**SHOP DRAWING REVIEW**

APPROVAL STAMP:	<b>J.P. CARRARA &amp; SONS INC.</b> Precast & Prestress Manufacturer 2464 OUSE ST., MIDDLEBURY, VERMONT 05753 Phone: (802)388-6361 Fax: (802)388-9010	<b>J.P. SICARD, INC.</b> CONTRACTOR BARTON, VERMONT
	<b>STATE OF VERMONT AGENCY OF TRANSPORTATION</b> COUNTY OF CALEDONIA	DATE: FEB. 6, 2017 SCALE: NOTED
	TOWN OF ST. JOHNSBURY VT ROUTE 2B, URBAN MINOR ARTERIAL BRIDGE NO.: 6 PROJECT NO.: BF 7000(20)	CHKD: M.W. DFTM: A.S. JOB NO: 23507-017
	<b>PRECAST FOOTINGS &amp; RAIL SUPPORT SLAB LAYOUT PLAN</b>	DWG. NO: <b>F1</b>

1 PRECAST FOOTINGS & RAIL SUPPORT SLAB LAYOUT PLAN  
3/8" = 1'-0"

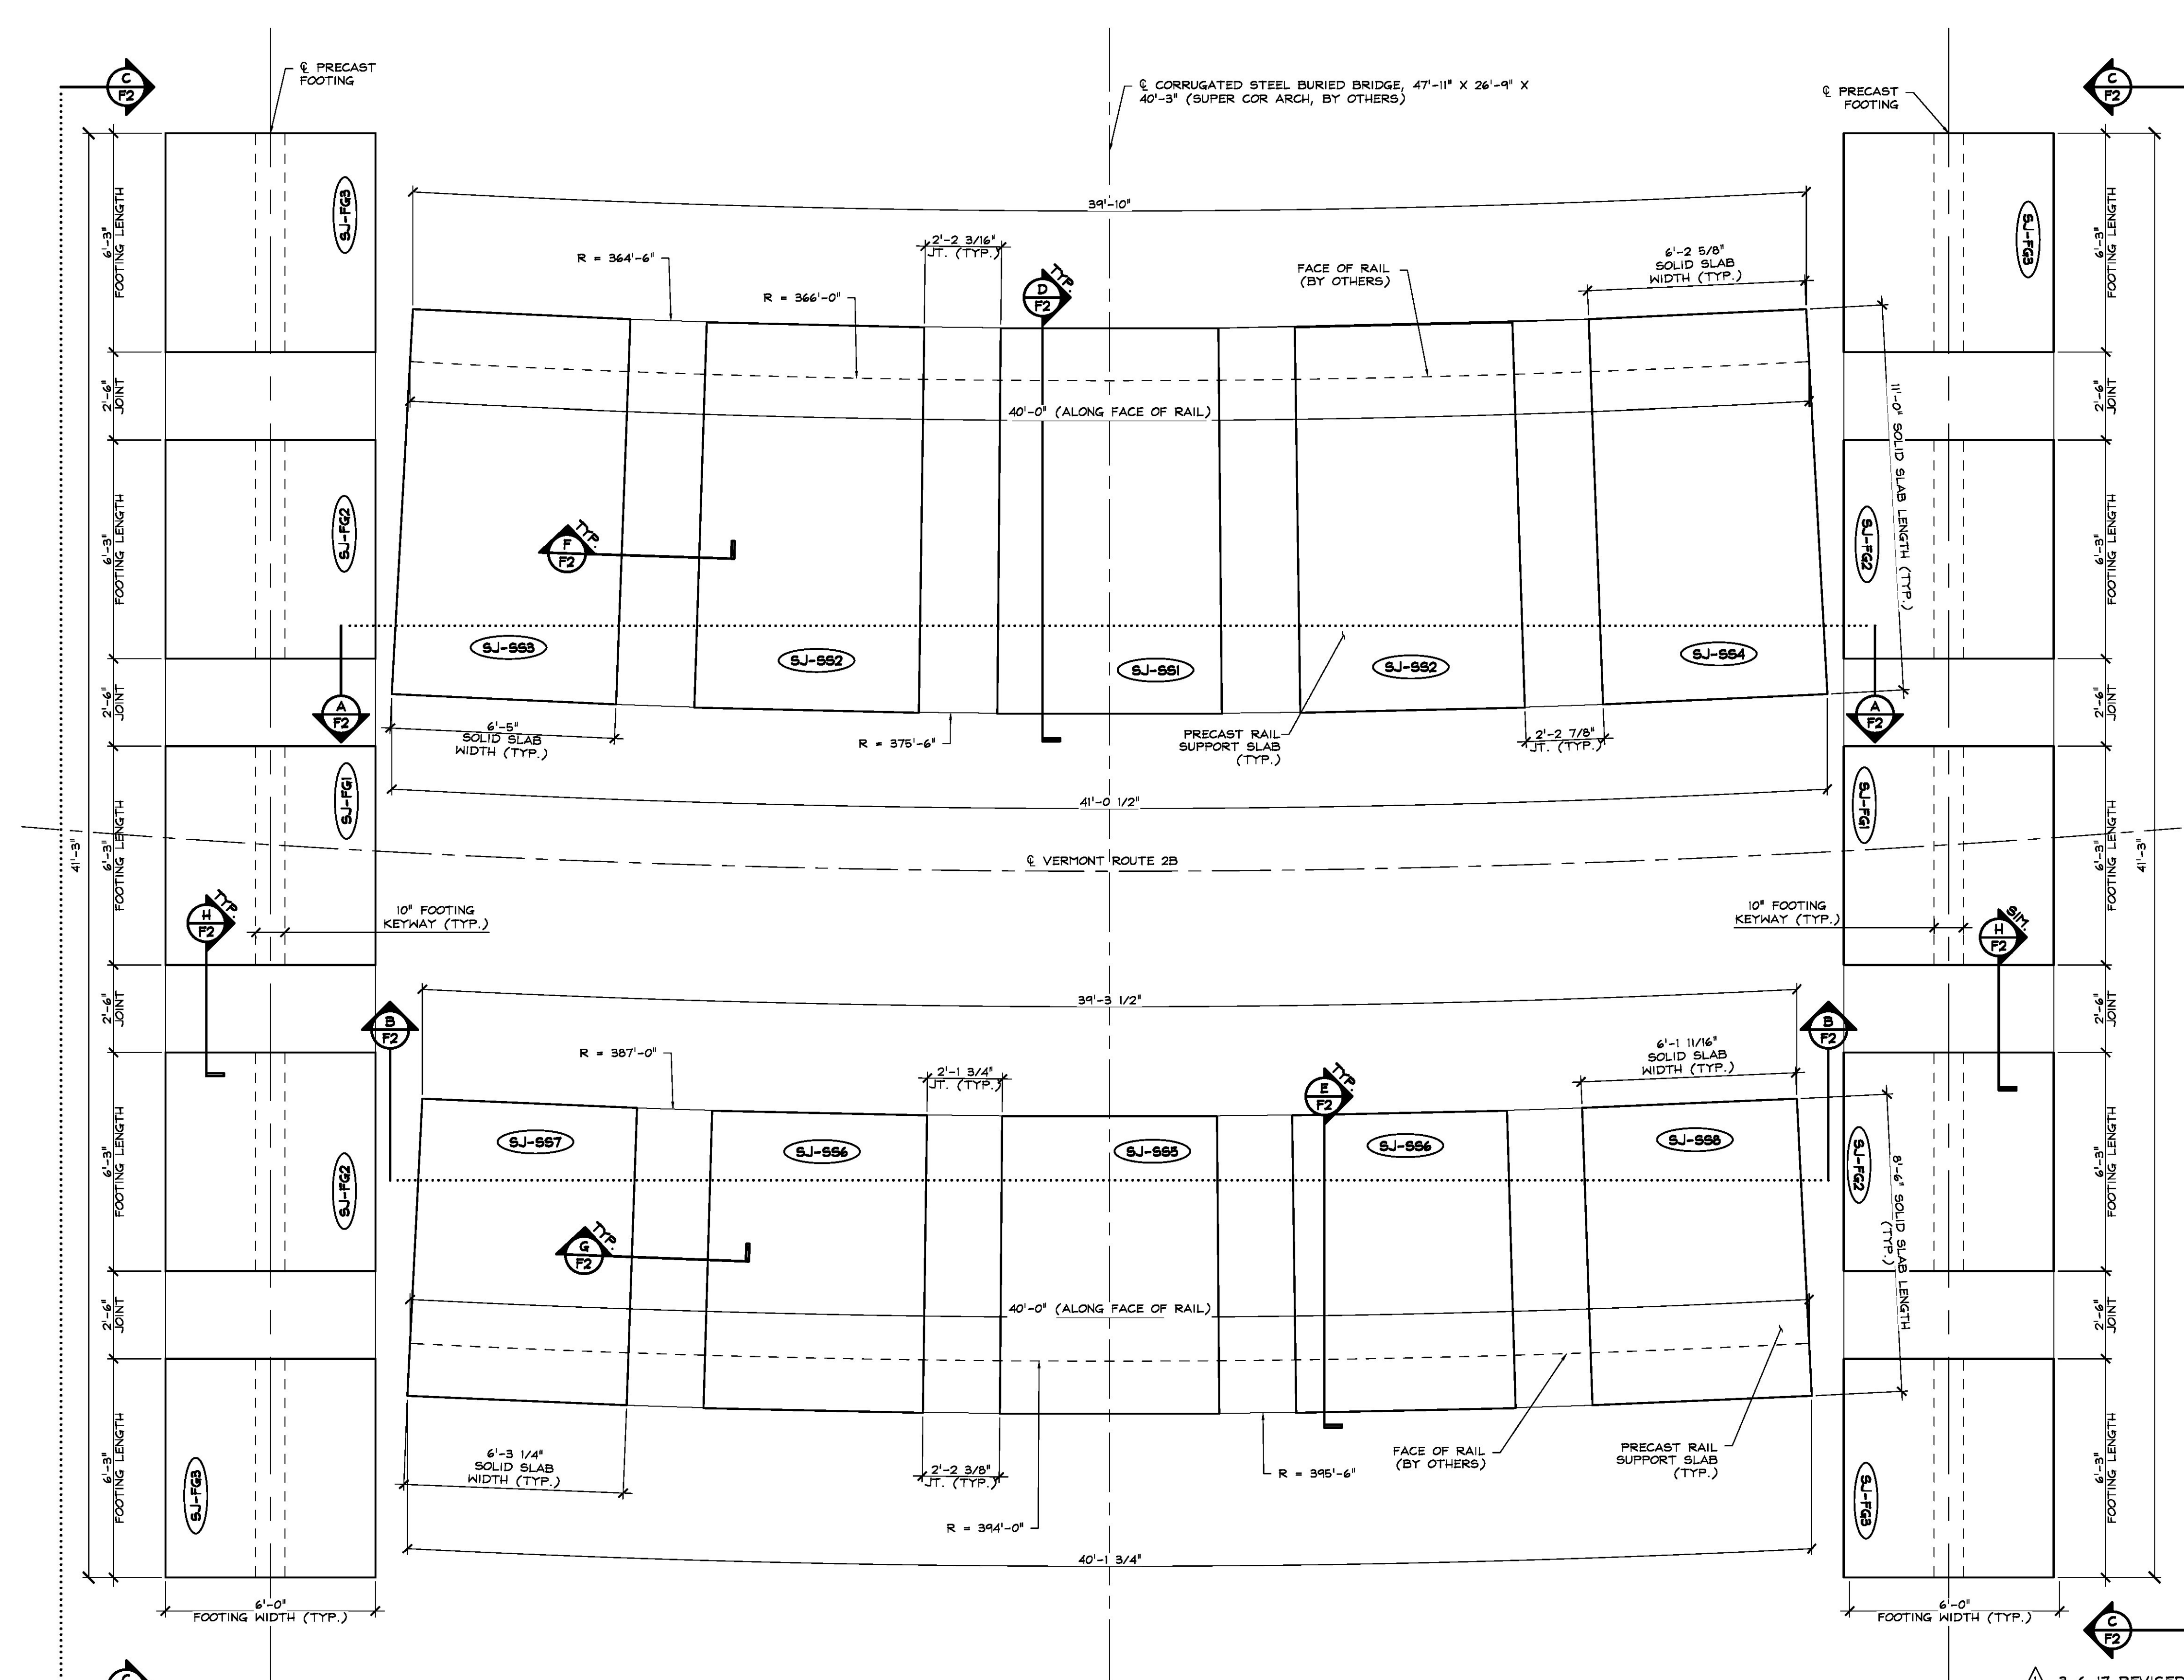
REJECTED     REVISE AND RESUBMIT     APPROVED AS NOTED

3-6-17 REVISED AS NOTED

RESUBMIT NO.    Approved
